July 2, 2010
DPG 10-158

**Subject: Cosumnes Power Plant (01-AFC-19)
Proposed Gate Reorientation**

**CONSUMER POWER PLANT
EQUIPMENT ARRANGEMENT
LAYOUT**

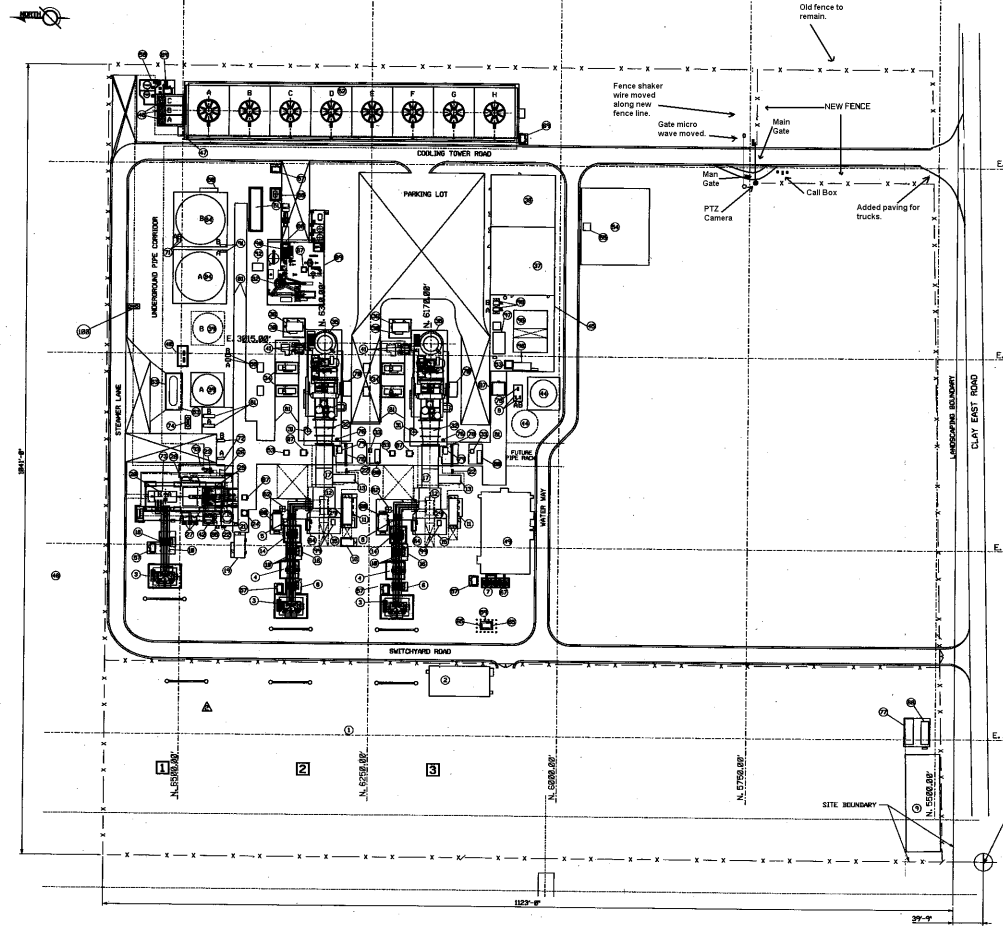
This letter is to inform you of the Cosumnes Power Plant's desire to move the east (main) entry gate approximately 130 feet north of its current location in order to enhance public safety and the safety of visitors waiting permission to enter CPP. The current entry protocol requires all visitors and delivery vehicles (including UPS, FedEx, chemical suppliers, etc.) to communicate via intercom with control room personnel in order to gain entry to CPP after identification is visually verified. In addition, larger delivery vehicles, particularly those conveying materials, products and chemicals must wait for manifest and vehicle inspection prior to escorted entry. This occasionally exposes vehicles to traffic on Clay East Road while awaiting access. Plant personnel suggested the proactive safety measure of simply moving the gate inward along the existing plant entrance road as shown in the attached sketch. A new fence segment would be installed, but the existing fence would also remain in place to define the current plant boundary and maintain security. This enhancement should provide adequate space and maneuverability to prevent visitors and their vehicles from being exposed to cross traffic.
